4 TCB SUBMISSION

This section addresses points specifically requested by EMCT upon submission to TCB selected by EMCT (Curtis-Strauss). The TCB requested clarifications are pasted in *italic*.

Figure 5 :Channel frequency tuning voltage

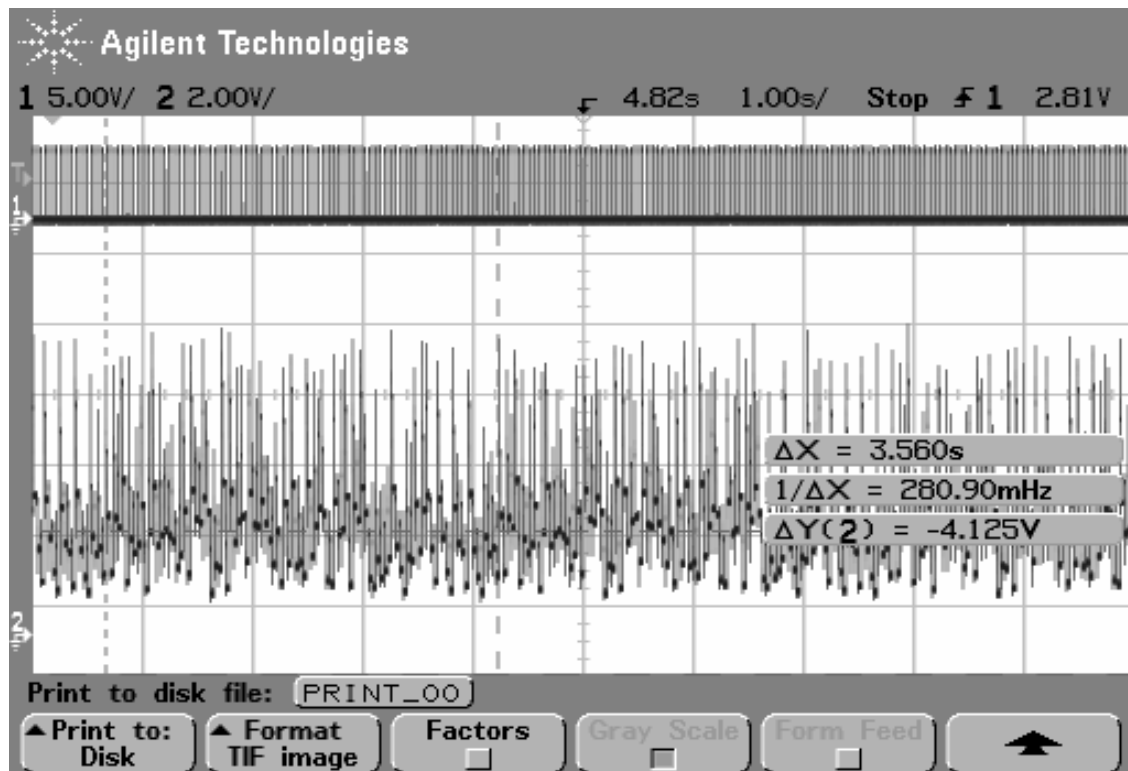
b. How is the equal use of each channel on average ensured by the device?

The frame time is user-configurable, 5ms to 35ms [9] with the **one setting being applied to all the channels in the hopping sequence**. Therefore equal use of all channels is guaranteed. Some evidence for this is shown in the following figure.

In figure 5 the lower trace is the tuning voltage on the channel changing main VCO of the EUT measured at TP1 of the circuit. The upper trace is the TX/RX switch line measured at TP34 and was used to trigger the oscilloscope. The vertical time cursors show where the pattern repeats indicating the period for a complete 102 channel hopping sequence.

Figure 7 : Carrier frequency separation

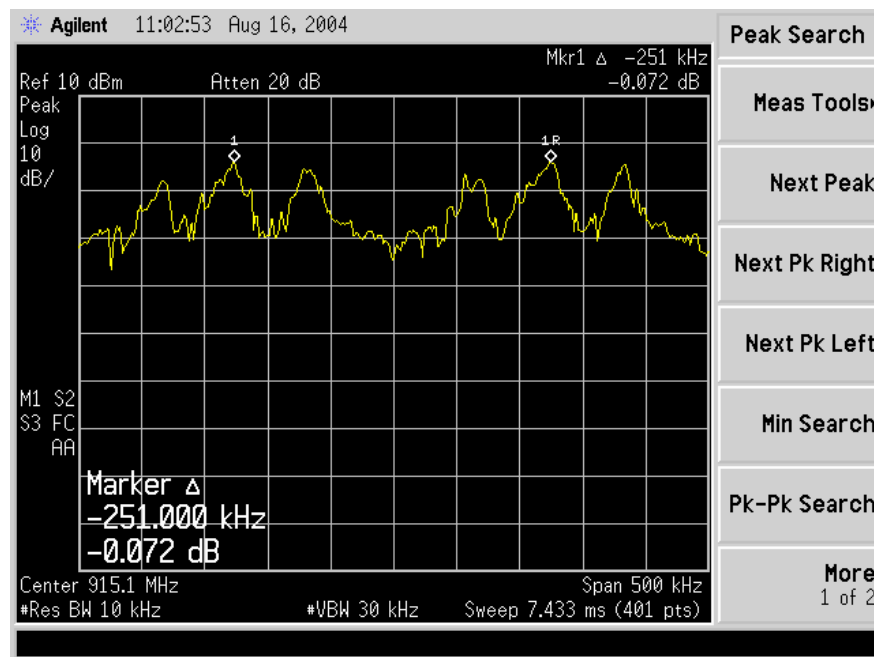
9. Carrier frequency separation plots are required in accordance with the test method described in the attached public notice DA 00-705. Please supply plots showing the separation between channels.

Figure 7 above shows a measured carrier frequency separation of 251 kHz. The spectrum analyser span was set to 500 kHz, wide enough to capture the peaks of two adjacent channels, while the RBW was 10 kHz (> 1% of span). The detector was set to peak and the trace was captured in peak hold.

Figure 8 :Dwell time on channel 50

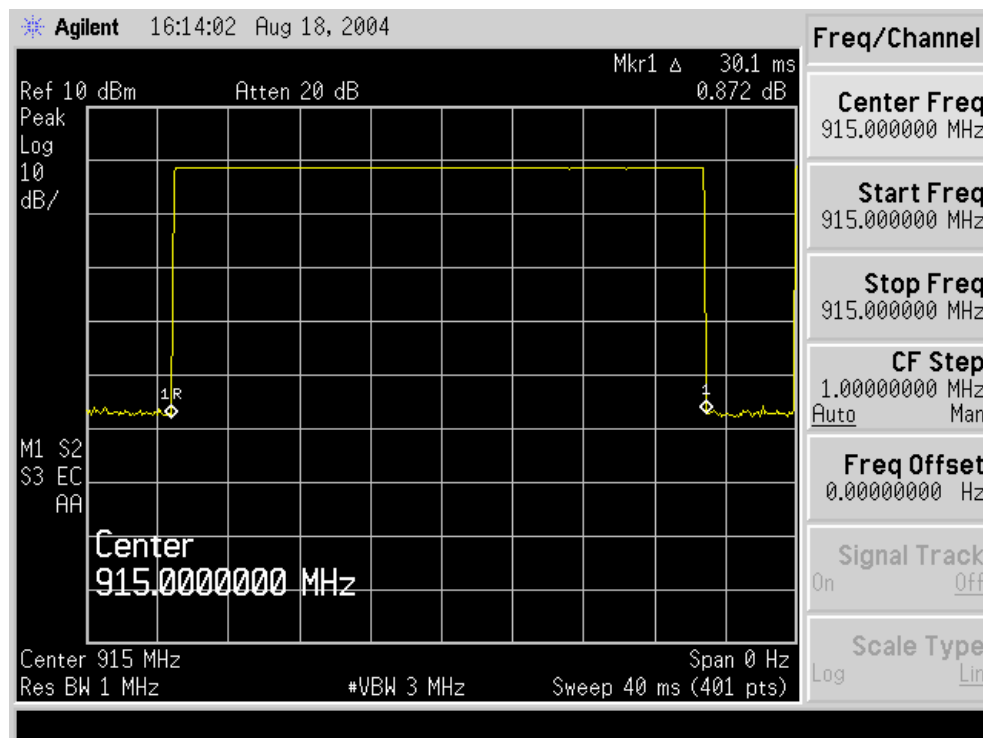
10. The analyzer settings for the dwell time (RBW, VBW, etc.) must be in accordance with DA 00-705. Please supply corrections.

This theoretical dwell time is the absolute maximum transmit dwell time and meets the 400ms requirement stated in 15.247(a)(1)(i) [2]. The actual maximum transmit dwell time is dependent on the time division duplexing of the frame into a transmit and receive (TX/RX) duty cycle. The default TX/RX duty cycle is 50% with a user selectable 'Directional bias' option, described in reference [9] p21-22. The worst case directional bias occurs with a frame time of 35ms. In this case the duty cycle is 93% [9]. This translates to a maximum TX dwell time of 32.6ms. The measurement shown below is this scenario with the TX data buffers full.

The detector was set to peak and the trace was captured in peak hold. Therefore the measured dwell time per hopping cycle is 30.1ms. To confirm the channel repetition period the sweep was increased to 20s, shown below.

Figure 12 : 20 dBc points for channel 0

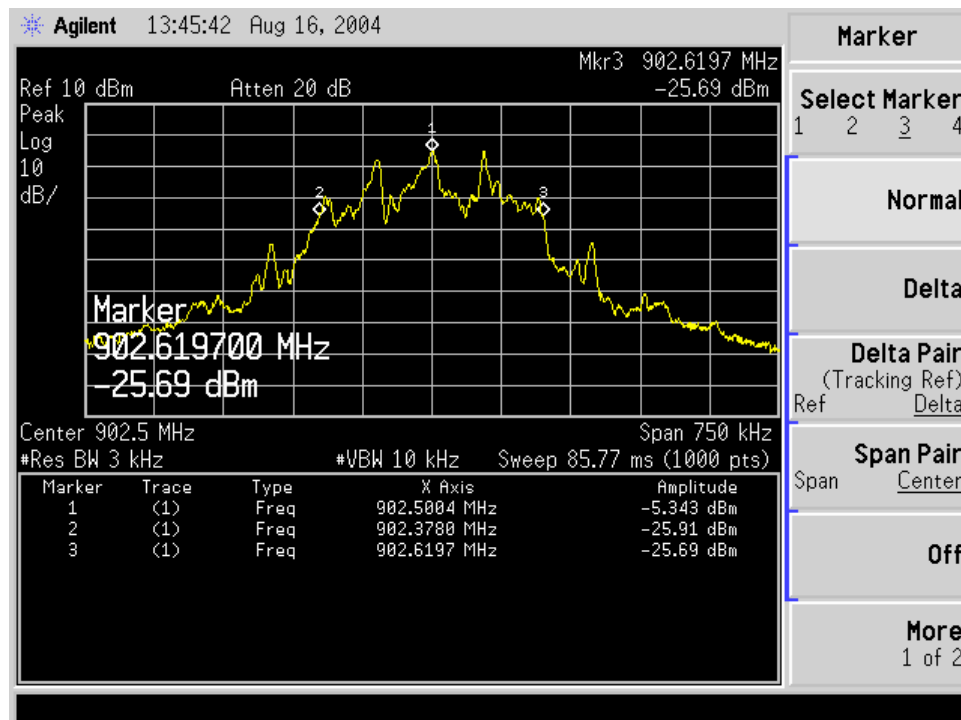
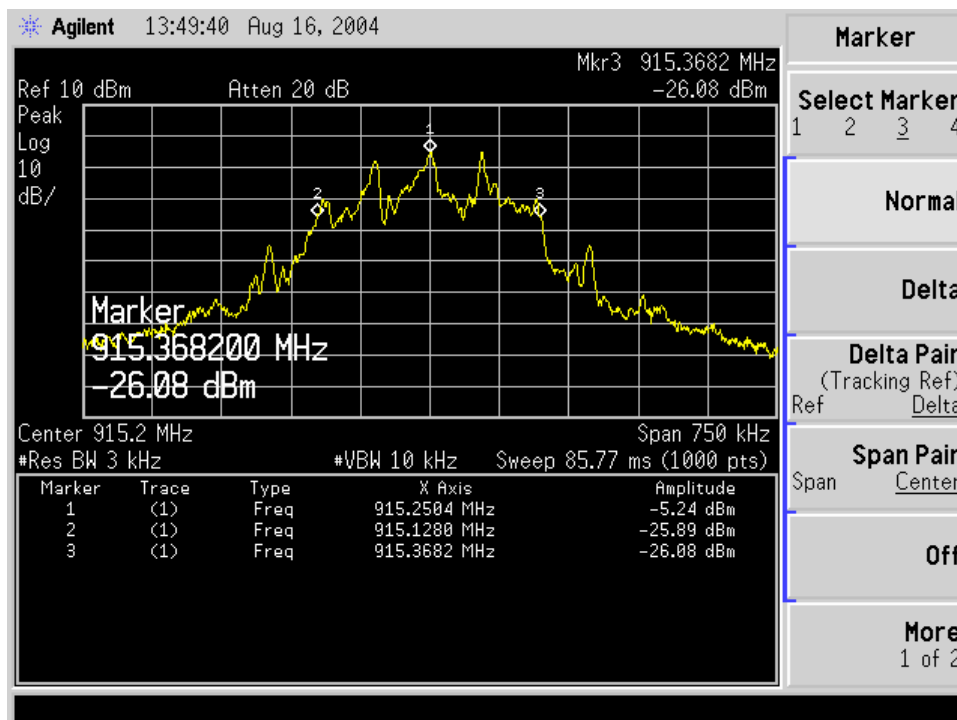
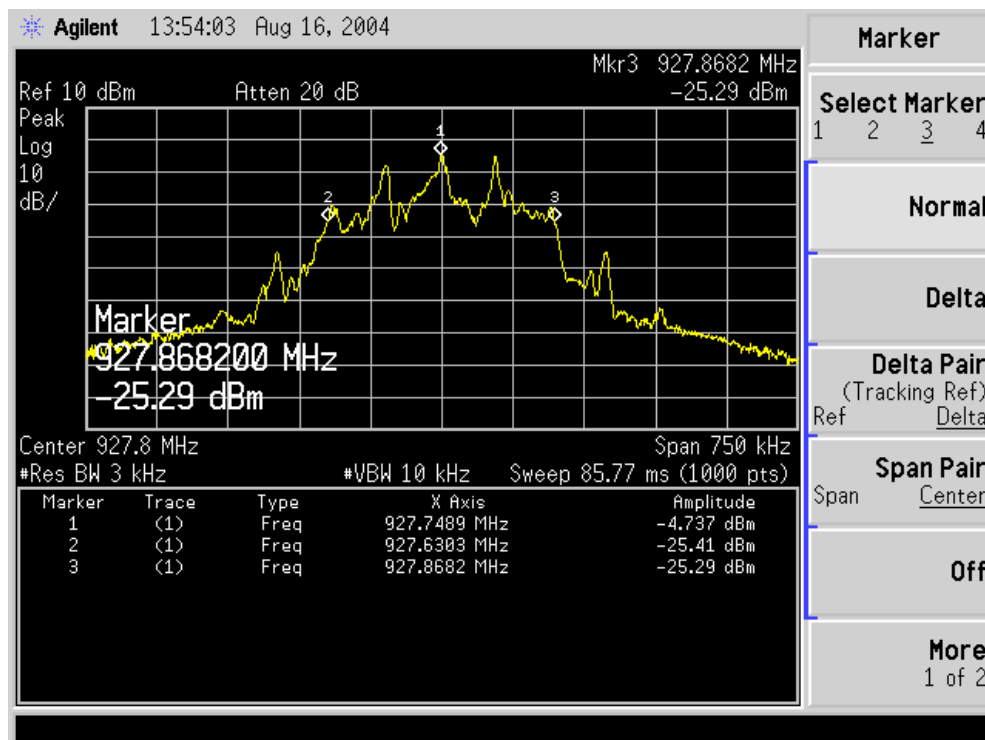
11. 20dB bandwidth of 255kHz is higher than the declared channel separation of 250kHz. According to 15.247(a)(1), frequency hopping systems shall have hopping channel carrier frequencies separated by a minimum of 25kHz or the 20dB bandwidth of the hopping channel, whichever is higher. How does the device comply with this requirement? Please clarify.

Figure 12, Figure 13 and Figure 14 illustrate 20 dB bandwidth measurements for channels 0, 51 and 101.

The span was set to 750 kHz, which is approximately 3 times the 20 dB bandwidth, while the RBW was 3 kHz (required RBW > 1% of 20 dB bandwidth, in this case > 2.4 kHz). The detector was set to peak and the trace was captured in peak hold.

Table 14 below lists the 20 dB bandwidths calculated directly from the screenshots above. Since the channel frequency separation of 251 kHz is greater than the 20 dB bandwidths shown below, the relevant subparagraph in section 15.427(a)(1) is satisfied.
